Rev B 07.07.16 Issued for planning submission
 Rev A 03.12.15 Issued for planning submission

Project No. **14029**
 Client **GFZ Developments Ltd.**
 Date **October 2015**
 Scale **1:100 @ A3 / 1:50 @ A1**
 Project **7 Warwick Court**

Drawing Title: **Demolition & Proposed Ground Floor Plan**
 Drawing No. **P_01** Rev. **B**
 Drawn **DI** Approved **MW** Signed **AB**

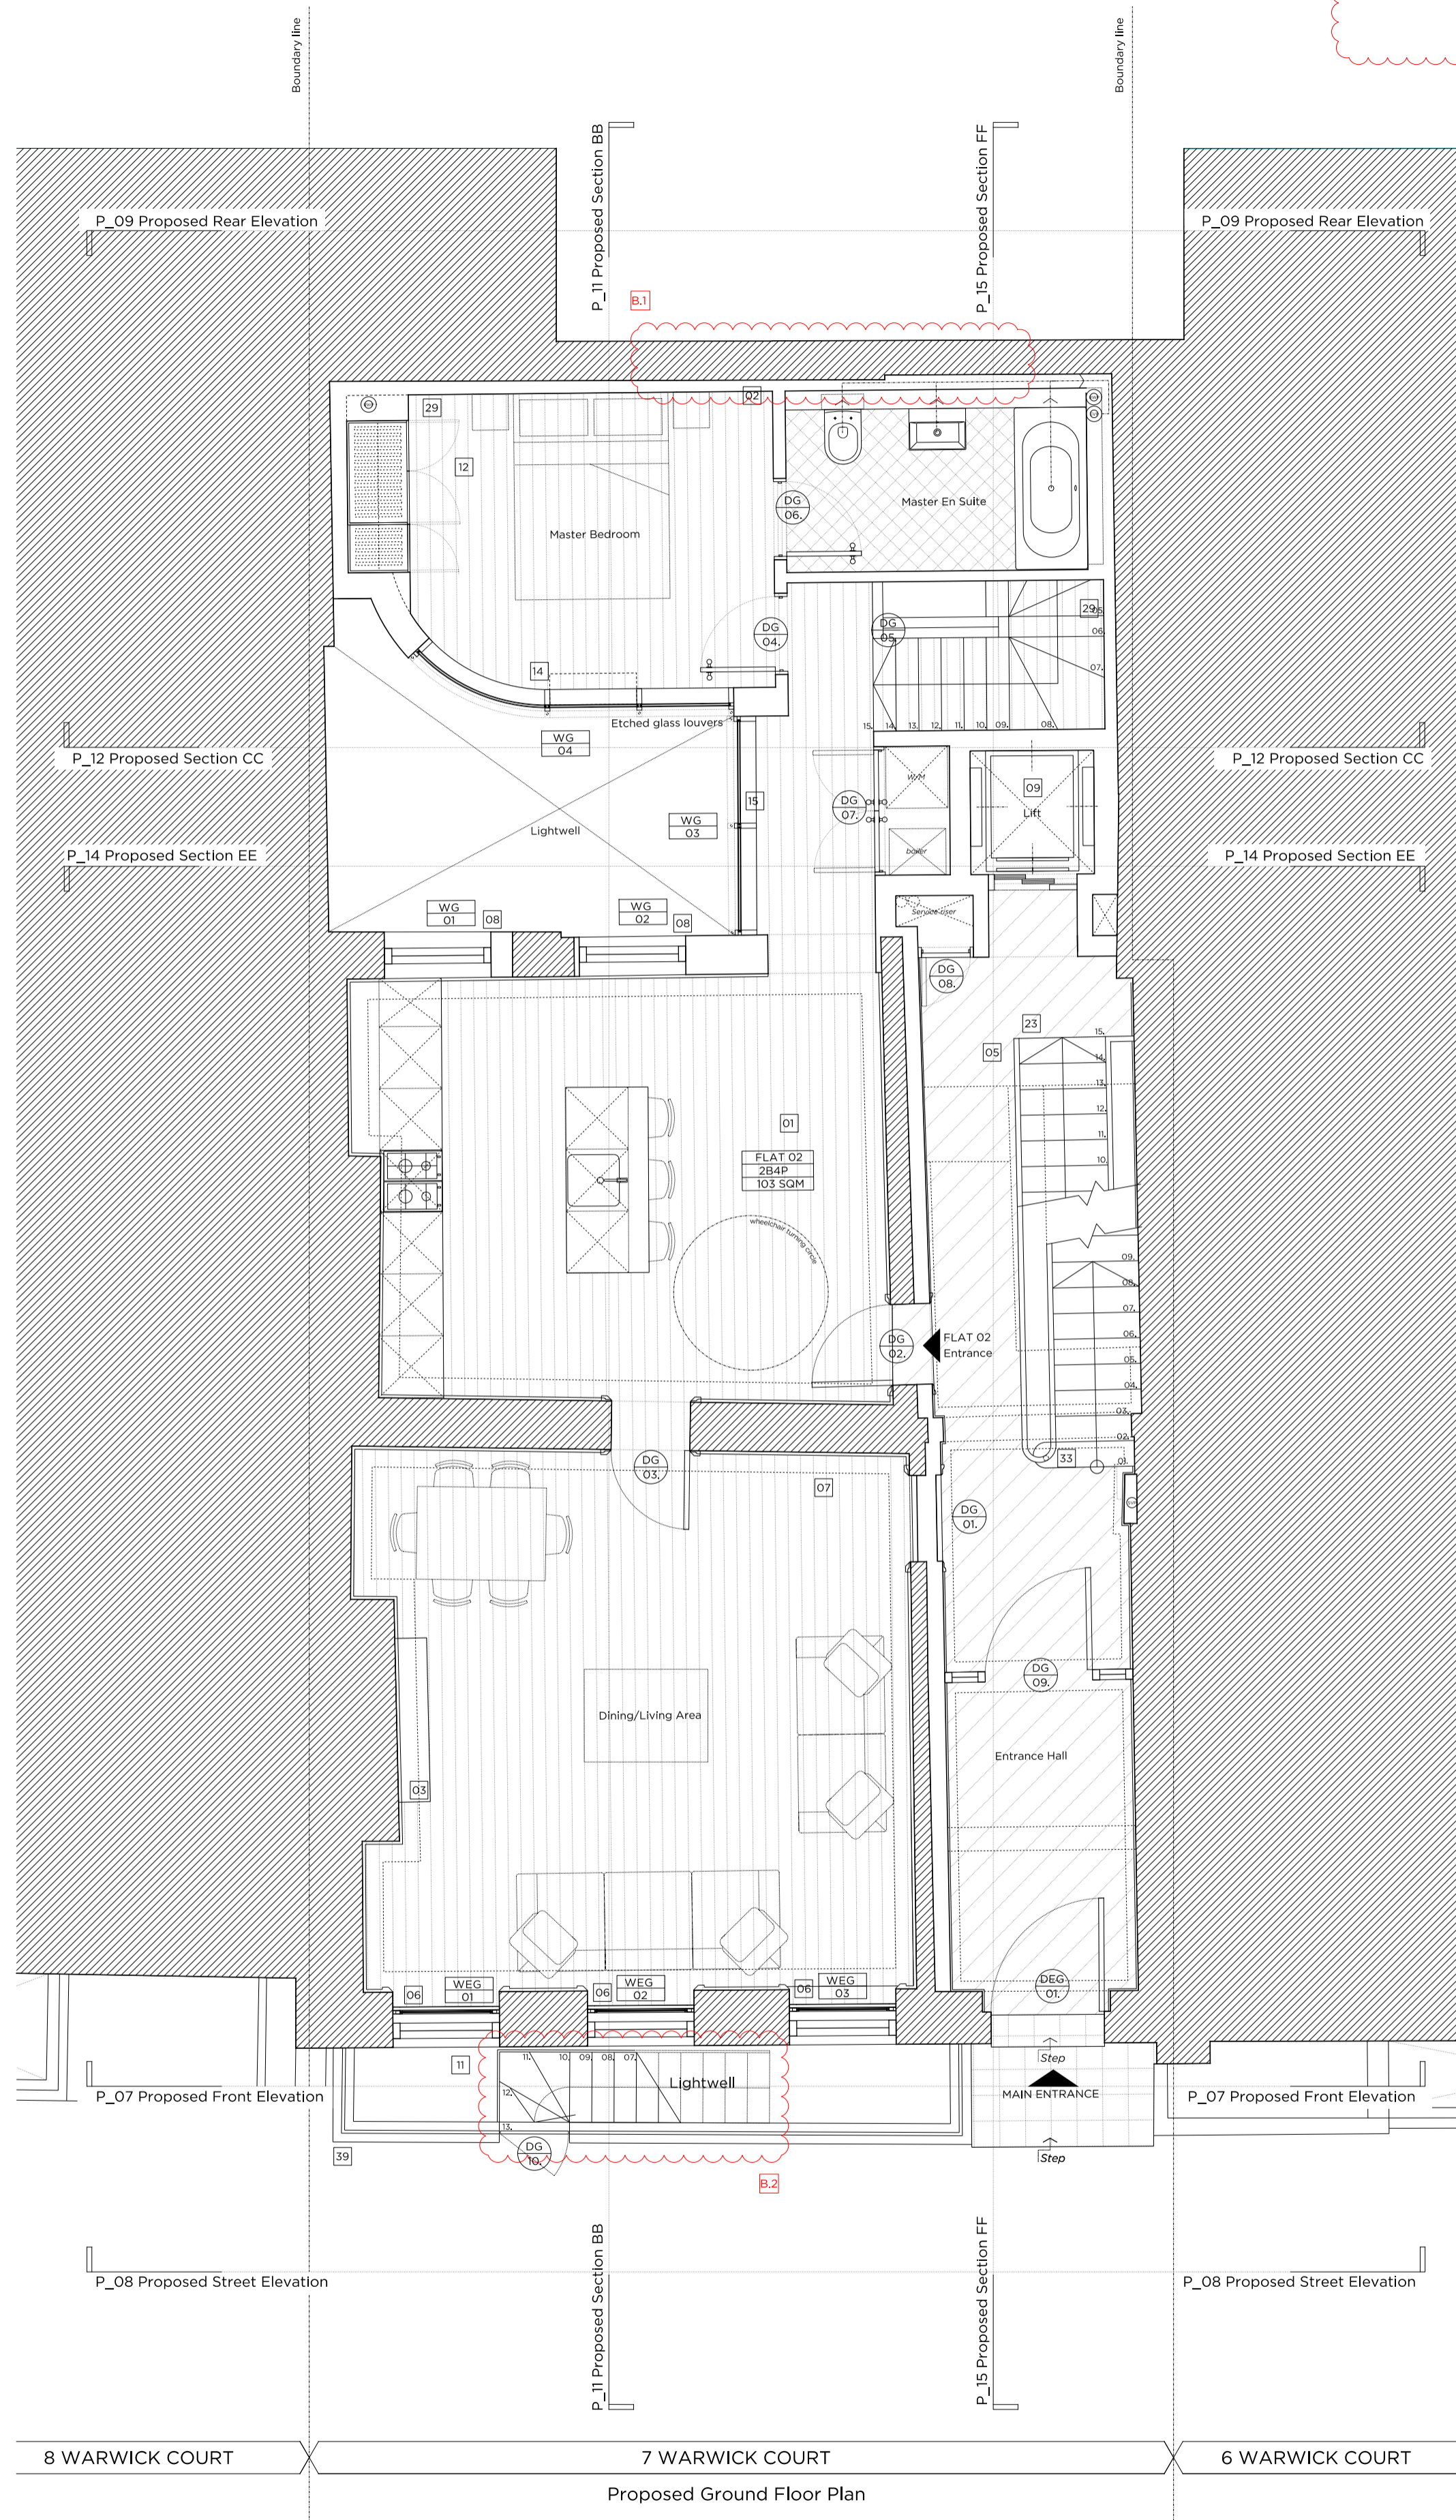
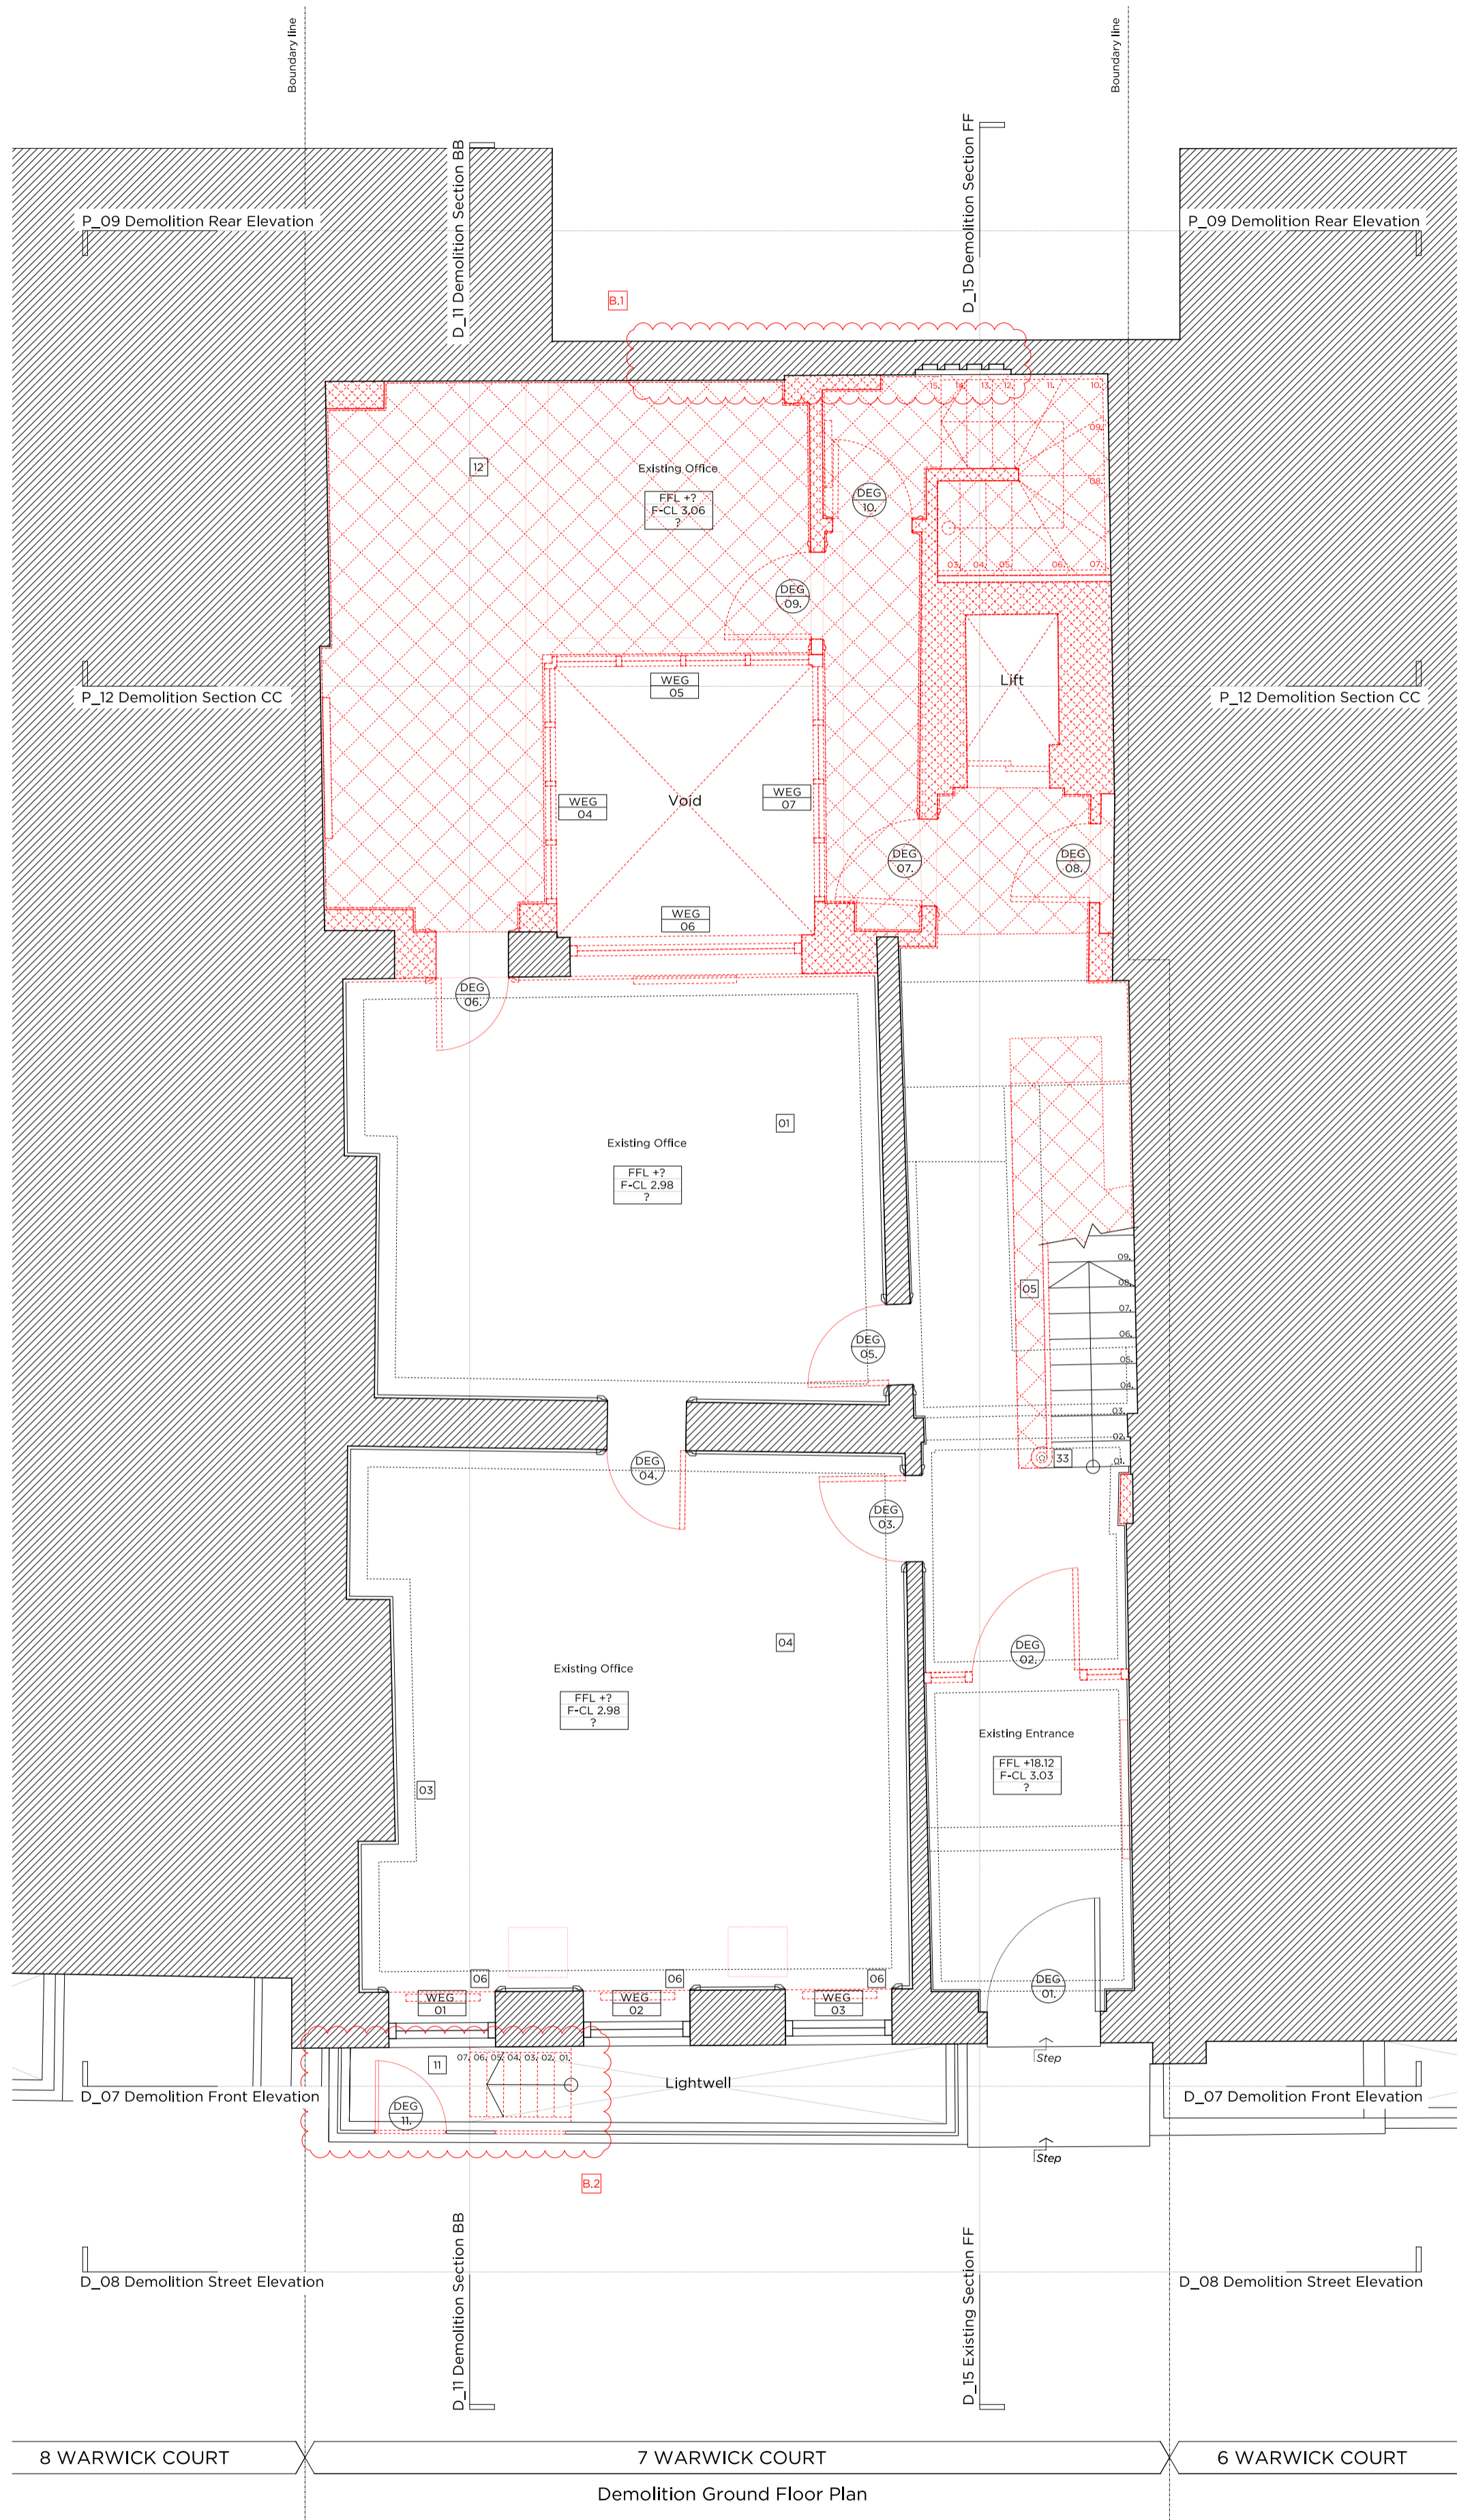
B.1 Window in rear wall which has been shown as existing now removed.

B.2 Lightwell stair and access gate position altered.
